STAFF RECOMMENDATION
2805 27th Avenue South
February 21, 2018

Application: New construction – addition
District: Hillsboro-West End Neighborhood Conservation Zoning Overlay
Council District: 18
Map and Parcel Number: 11703001000
Applicant: Manuel Zeitlin
Project Lead: Melissa Baldock, melissa.baldock@nashville.gov

Description of Project: Application is to construct a rear addition with an attached garage at the basement level. The addition extends wider than the historic house.

Figures 7 & 8. The site plan (left) shows an attached garage at a location wider than the house. The Metro Map (right) shows the existing garage, to be demolished, in the same approximate location as the proposed attached garage.

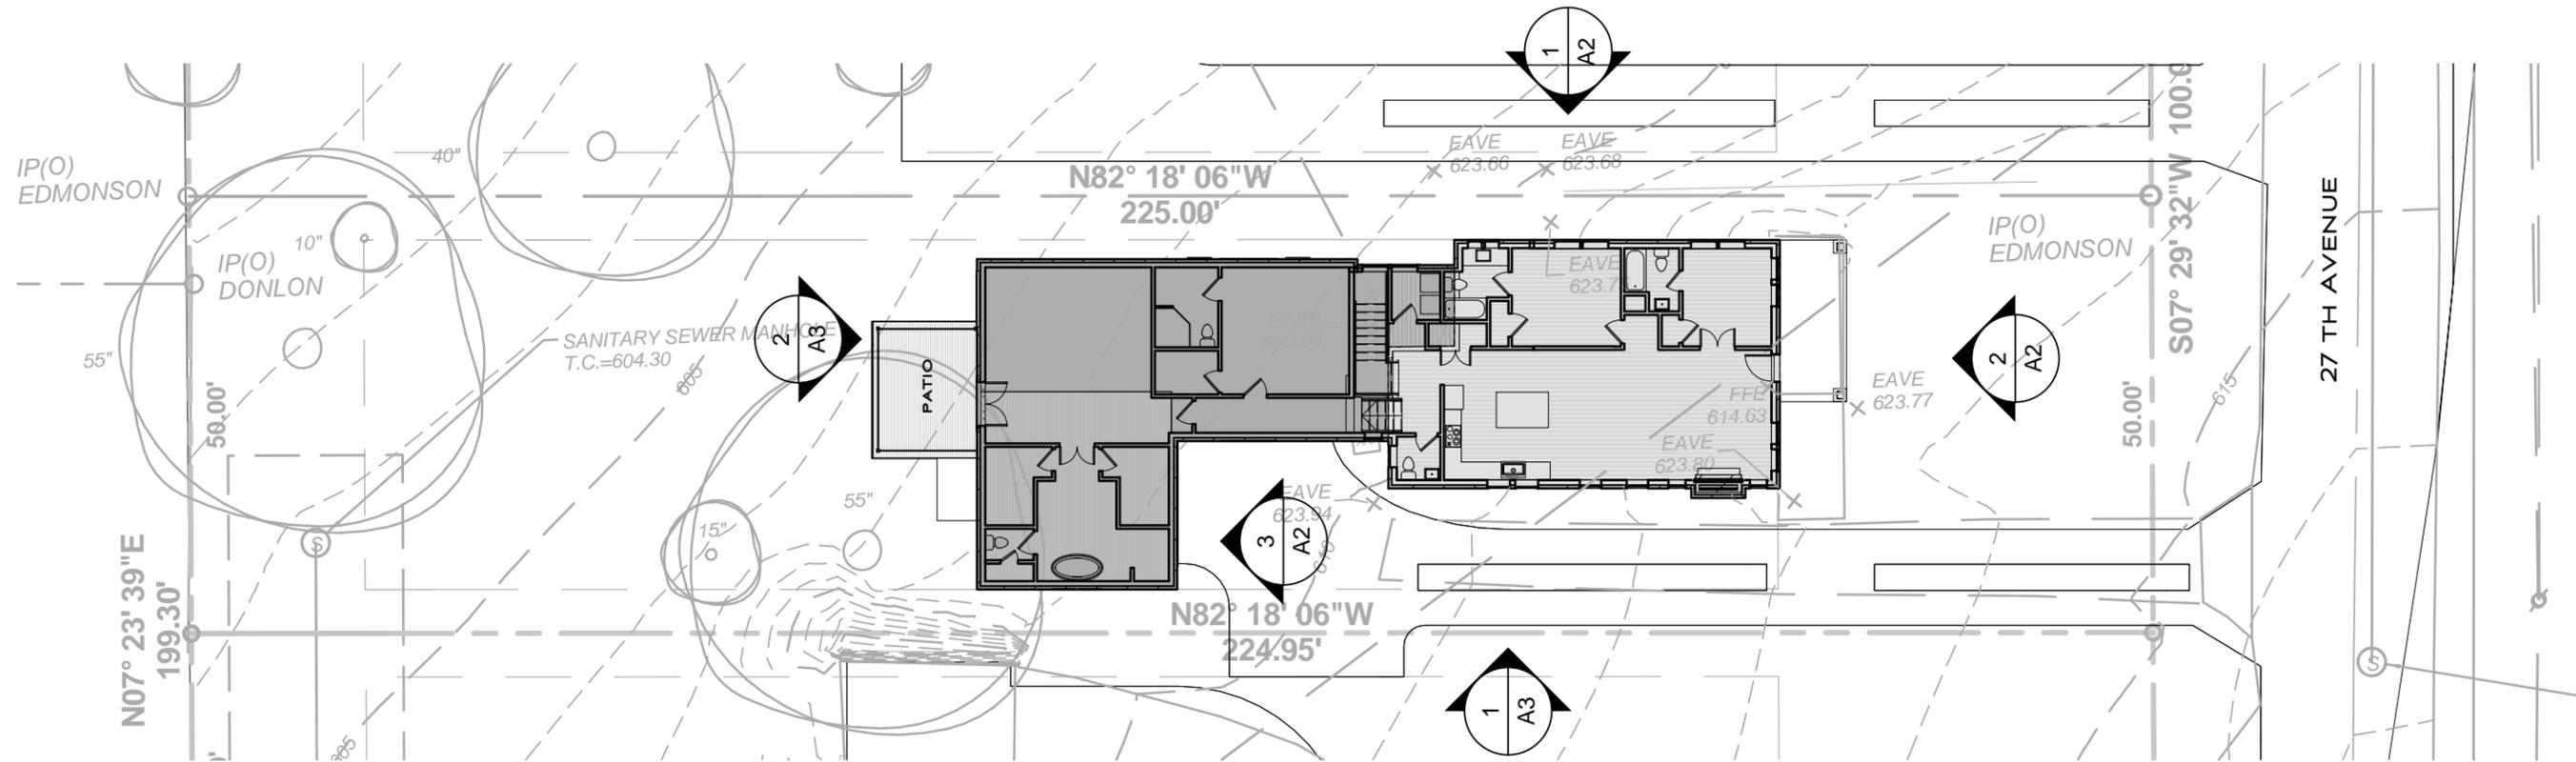
Outbuildings: The infill includes an attached garage where the addition is wider than the historic house. The design guidelines state that attached garages can be appropriate when they are located at the basement level and when they are located in areas where an outbuilding would have been historically. In this case, the garage is located at the basement level. Since this lot lacks an alley, historically an outbuilding would have had garage doors facing the street and would have been located to the side of the historic house. In fact, the existing outbuilding, which is to be demolished, is located in the approximate area as the proposed attached garage (Figures 7 & 8). From the street, the attached garage will have more of an appearance of a separate garage structure. Staff finds that the proposed attached garage meets Section II.B.1.h. of the design guidelines.
